ADDENDUM NUMBER ONE

DARLA MOORE SCHOOL OF BUSINESS CONSTRUCTION – BP-3
ENCLOSURE/SITE/MEFP/INTERIOR
UNIVERSITY OF SOUTH CAROLINA
STATE PROJECT NUMBER H27-6069-AC-3

DATE OF ISSUE: June 04, 2012

CHANGE OF GLAZING TYPES AT LEVEL 4 PERIMETER - WEST ELEVATION
REF. DWG # A2221, A2222, A3305
SHEET TITLE :

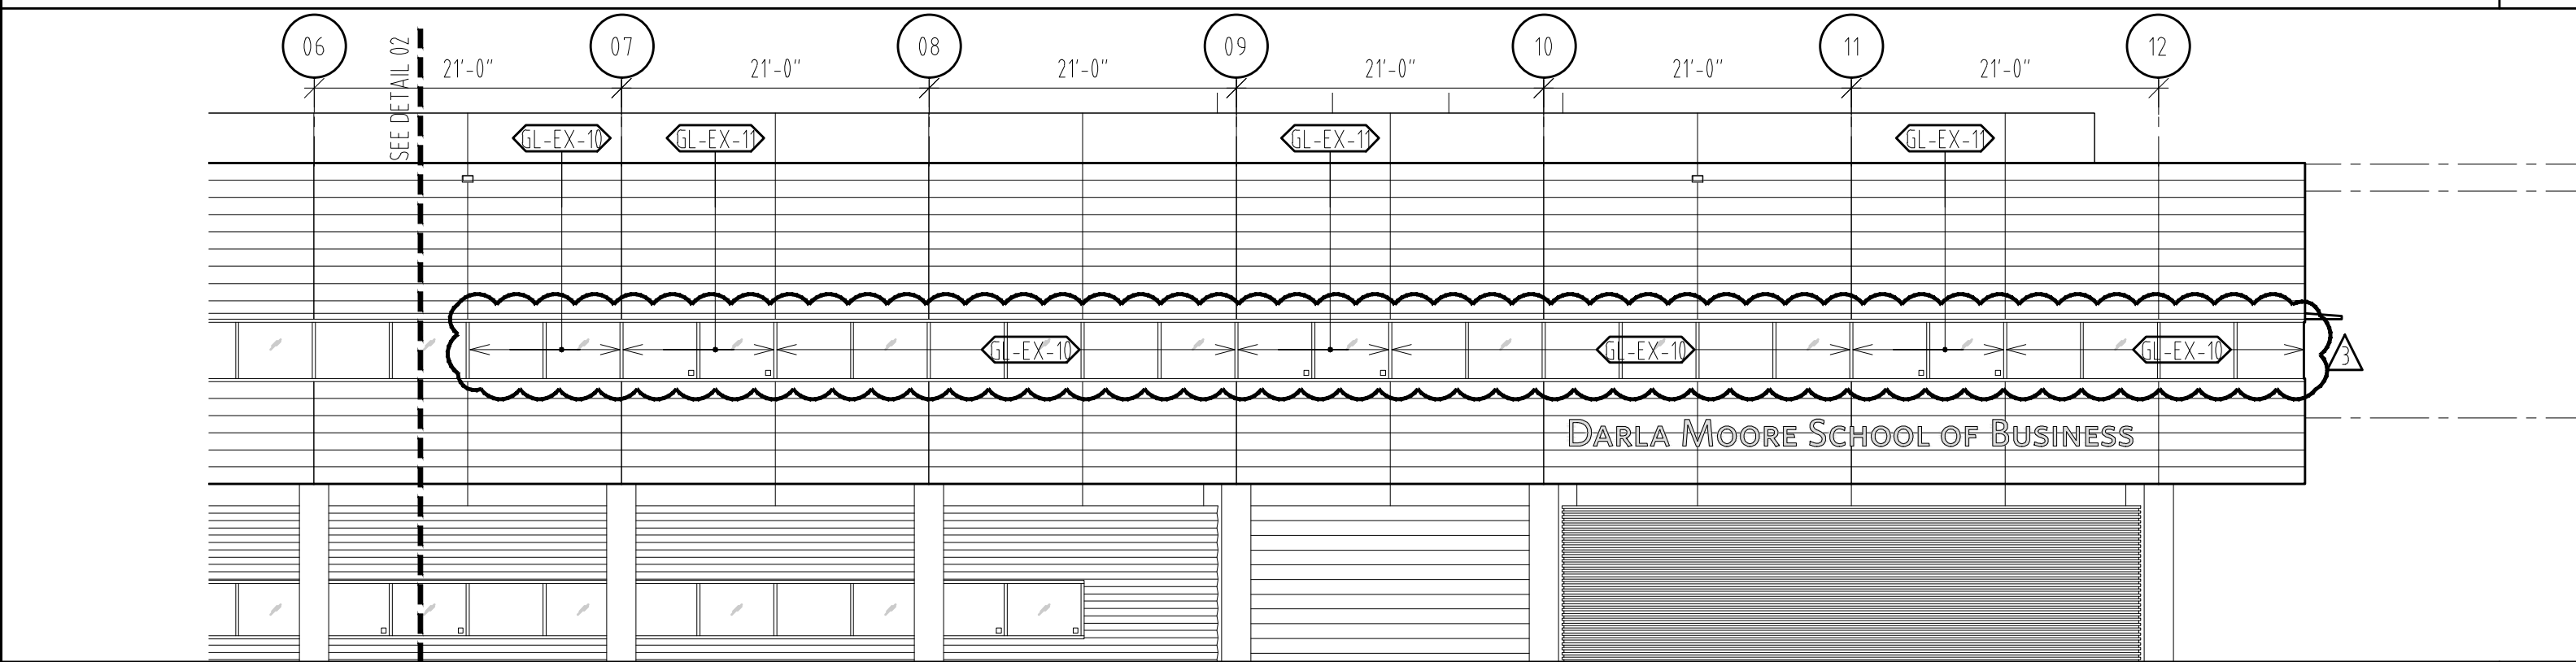
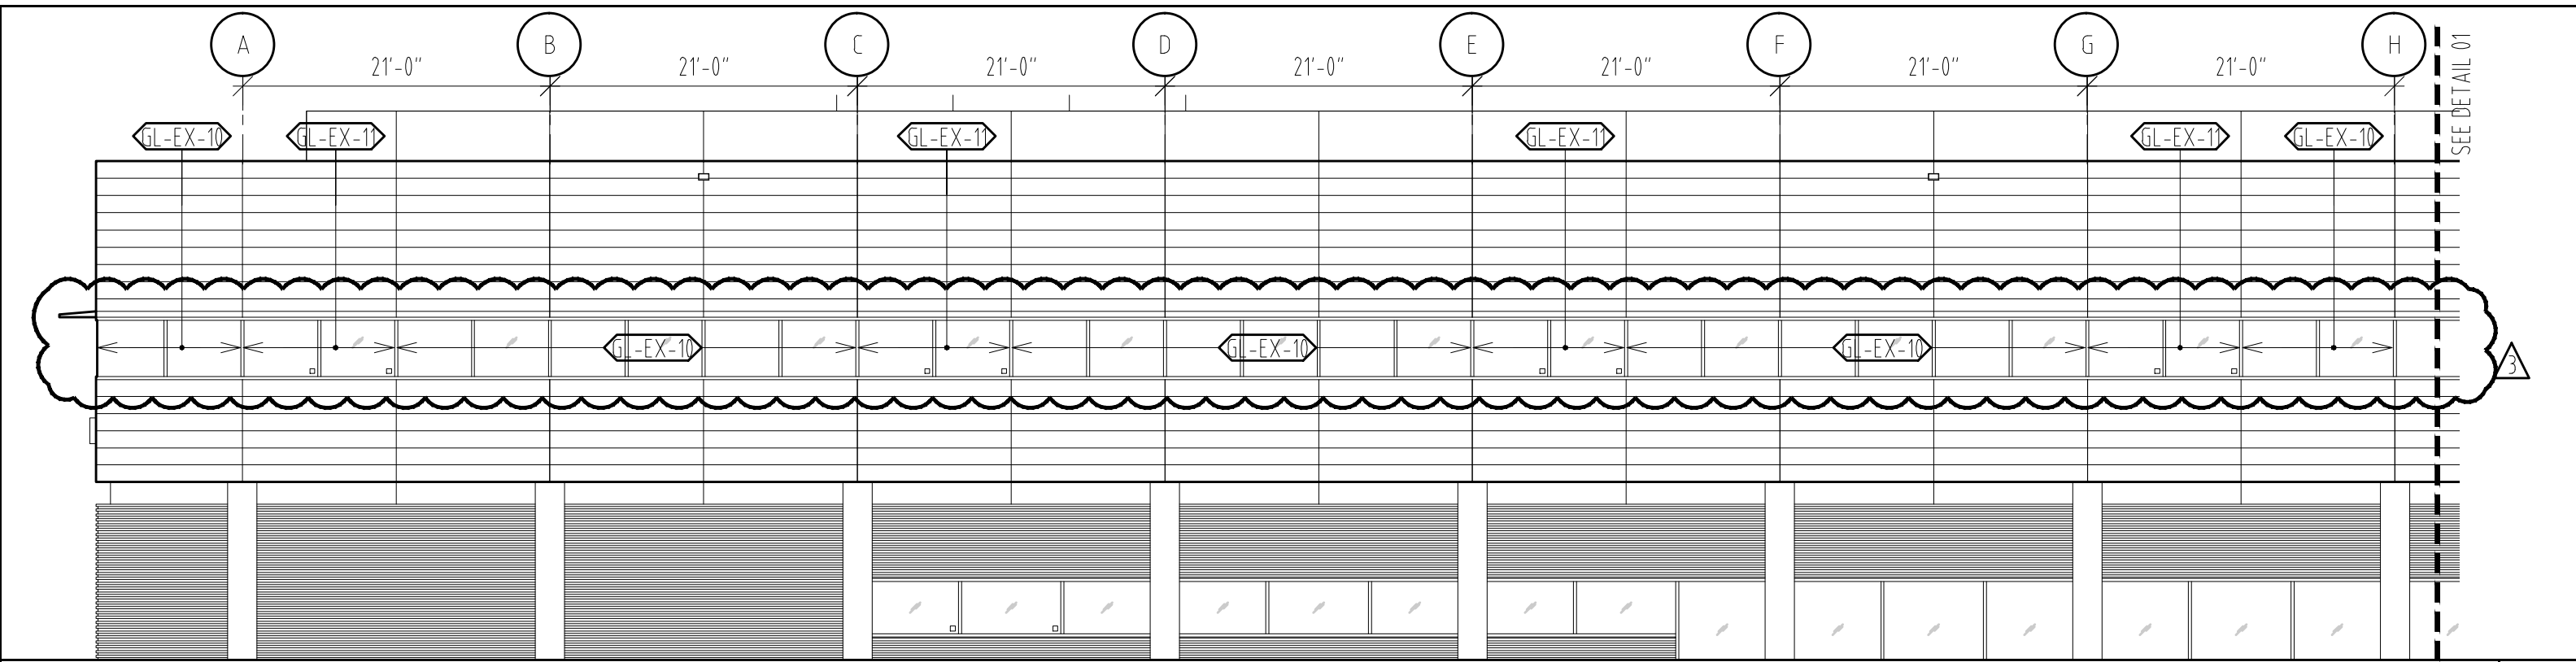
8.	Elevations Sheet A2201, A2221, A2222, A2231, A2232, A2202, A3304, A3305, A3306 and Glazing Schedule A4602: Refer to attached sketch A-SK-010, A-SK-011, A-SK-012, A-SK-013, and A-SK-014. Revisions to exterior glazing type at Level 4.

SUMP PUMP DISCHARGE PIPING LOCATION
REVISION
REF. DWG # C1500_bp3
SHEET TITLE :

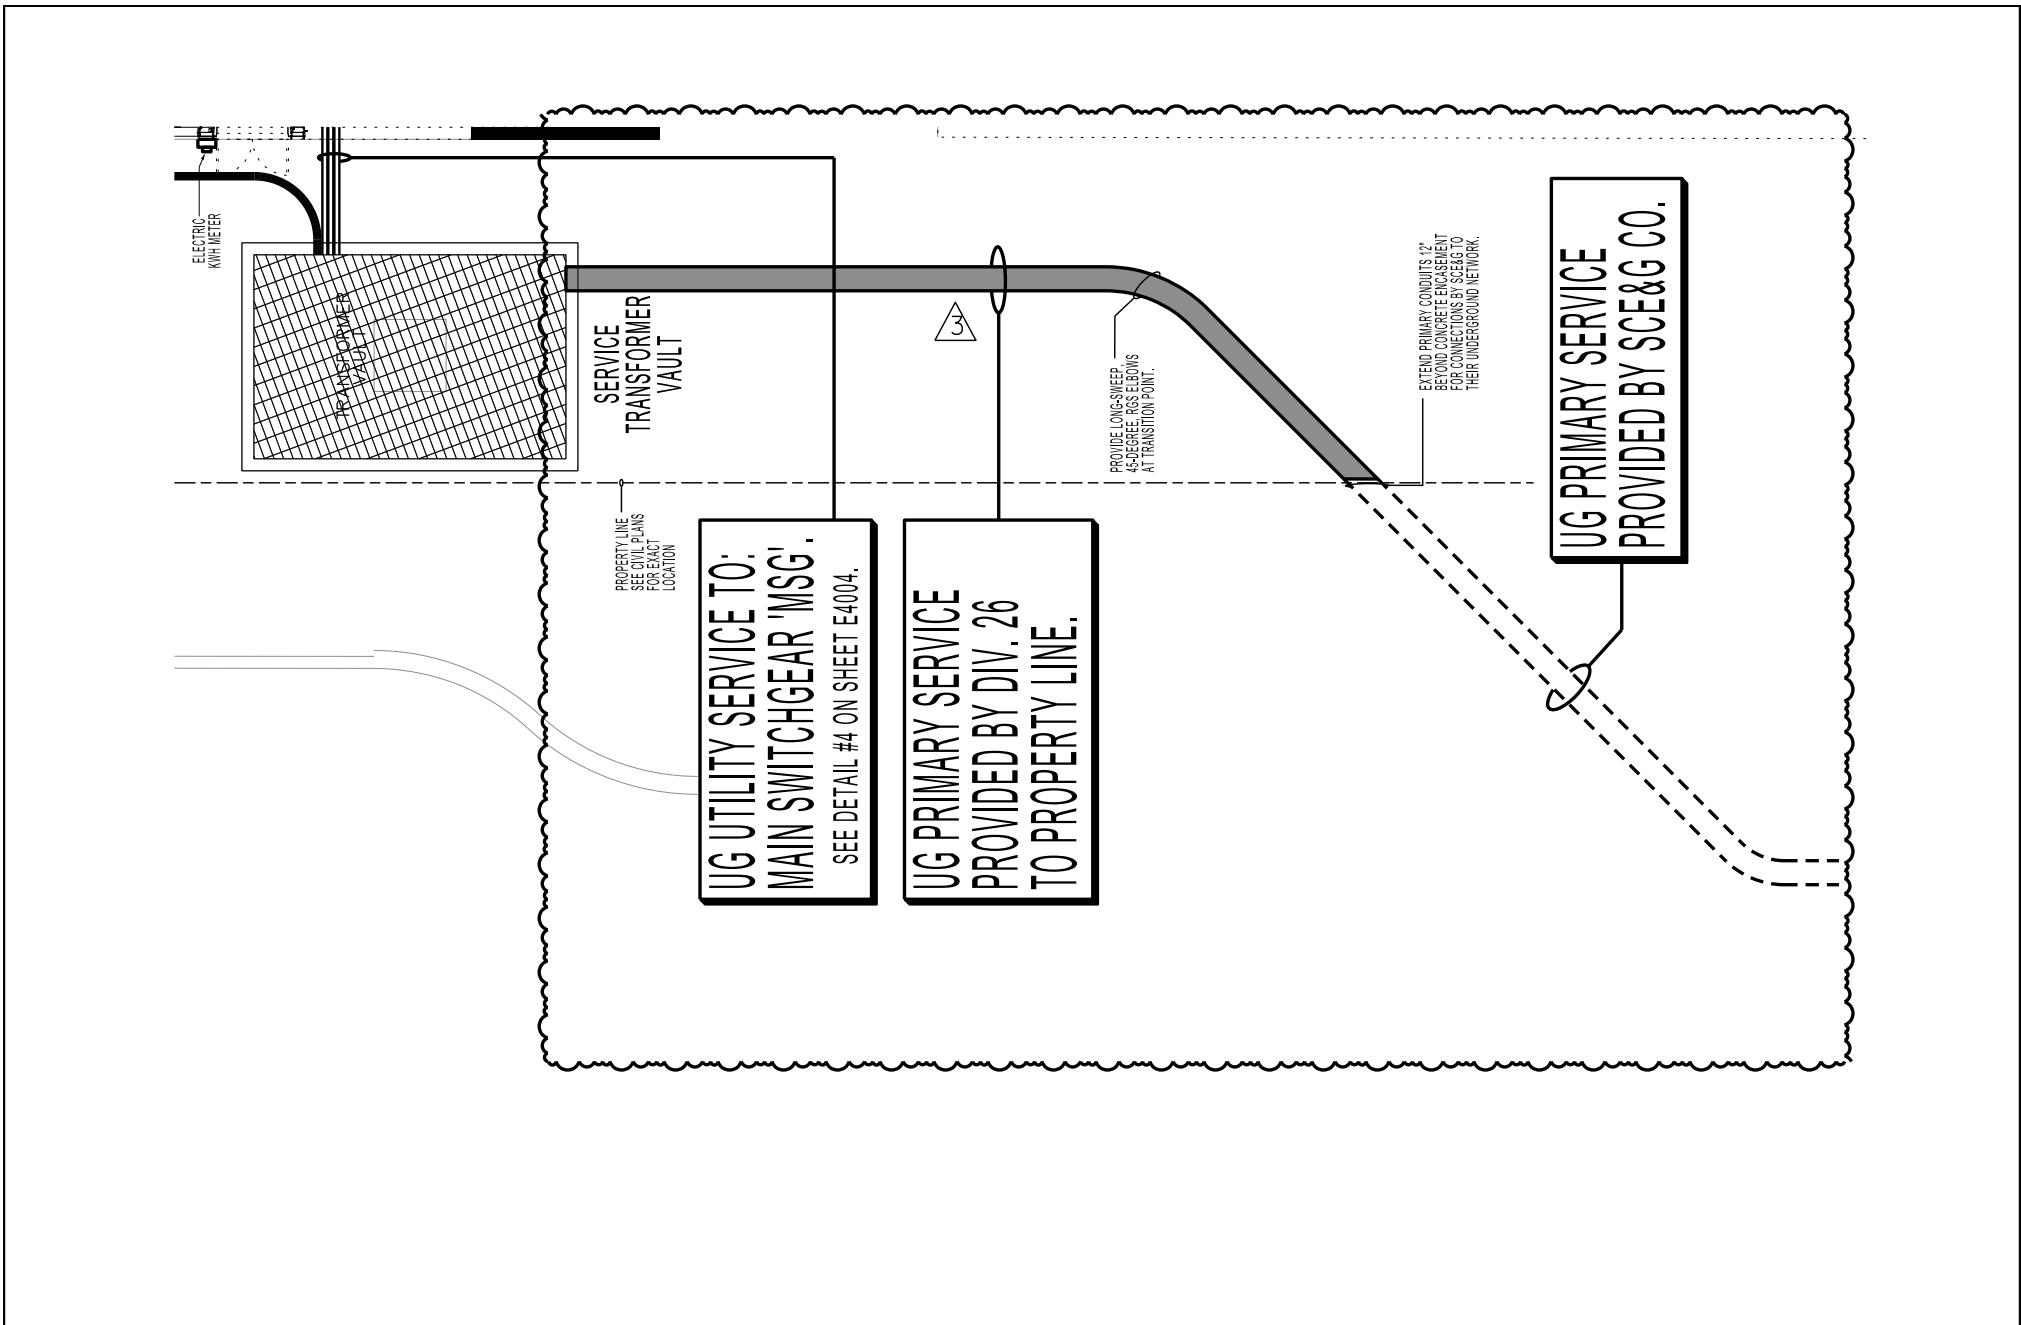
10. Plan Sheet C1500_bp3: Refer to attached sketch C-SK-001- Revise location of electrical vault sump discharge piping.
11. Plan Sheet M9150C & M9150D, revised scale from 1/16" = 1'0" to 1/4" = 1'0".

ADD ROUTING FOR PRIMARY DUCTBANK
 REF. DWG # E1000

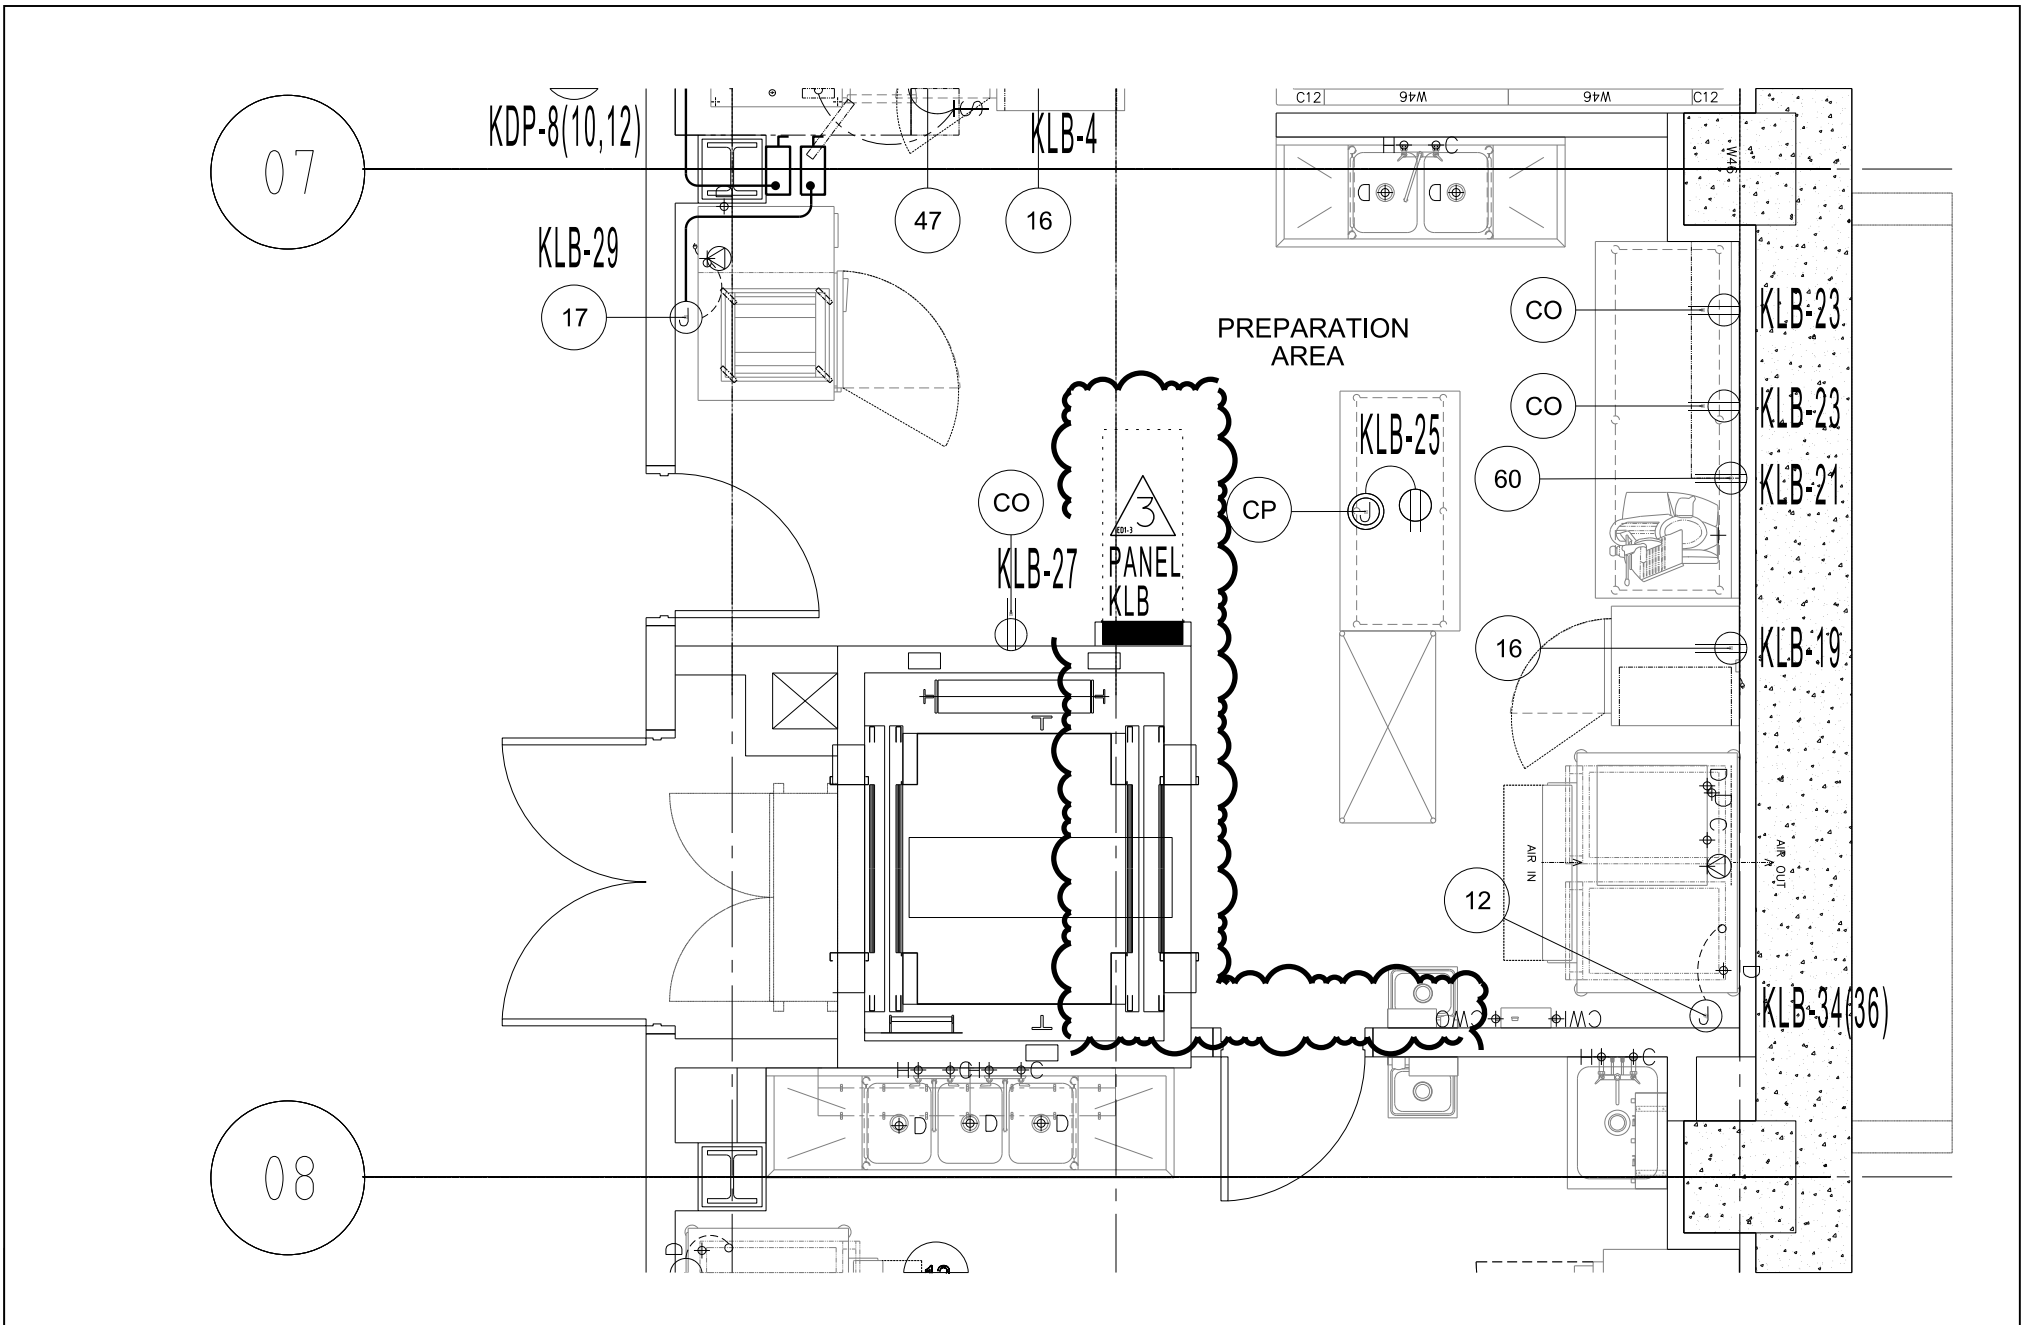
**-The Primary service ductbank has been revised from two-6" conduits, to six-6" conduits. The primary ductbank will be similar in section to the one shown in Detail #04 on sheet E4004, except that the primary conduits will be arranged as a 2x3 (or two-wide x three deep) ductbank, in lieu of the 4x2 ductbank shown in the referenced detail.*
18. Sheet E1000-Electrical Site & Subgrade Plan: Revise drawing to reflect information contained in the attached Sketch E-SK-001, which illustrates the proposed primary electrical ductbank routing from the electrical vault to the property-line for tie-ins to the local electric utility company's network.
19. Sheet E1201- Kitchen Power Plan Level 0: Revise drawing to reflect information contained in the attached Sketch E-SK-002, which illustrates the relocation of Panel KLB.

ADD CCT FOR KITCHEN OFFICE RECEPT.
REF. DWG # E3000

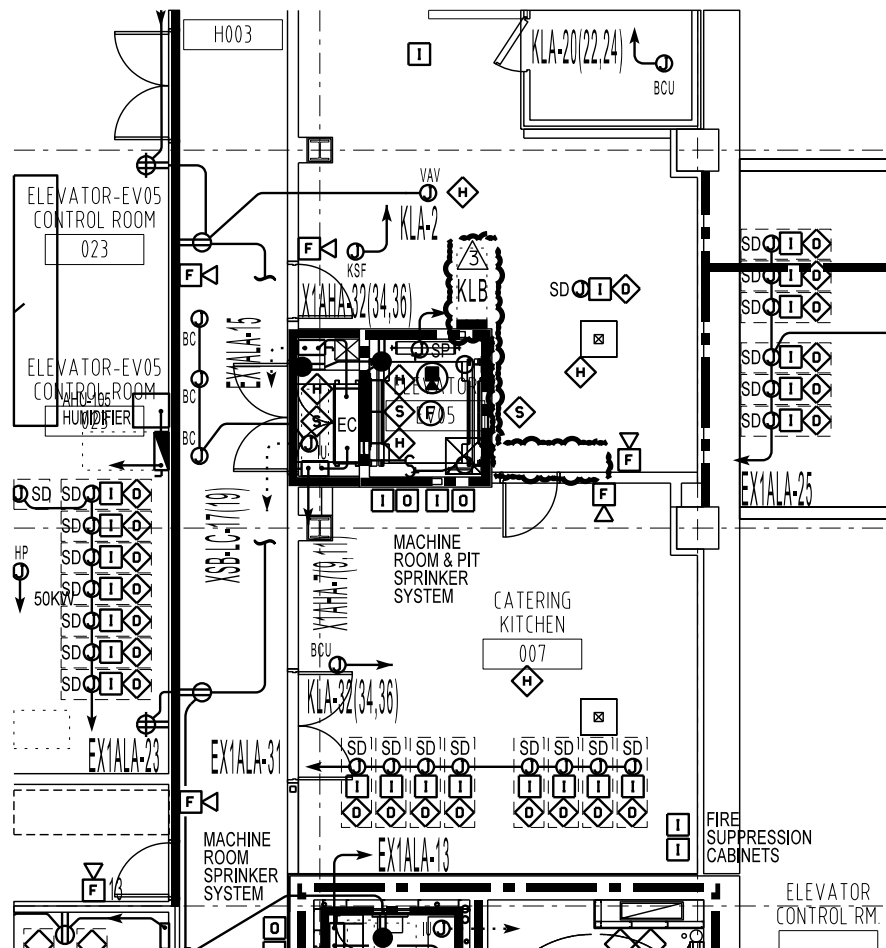
21. Sheet E3000- Panelboard Schedules Level 0: Revise drawing to reflect information contained in the attached Sketch E-SK-004, which illustrates the addition of a branch circuit to feed the kitchen office receptacles.
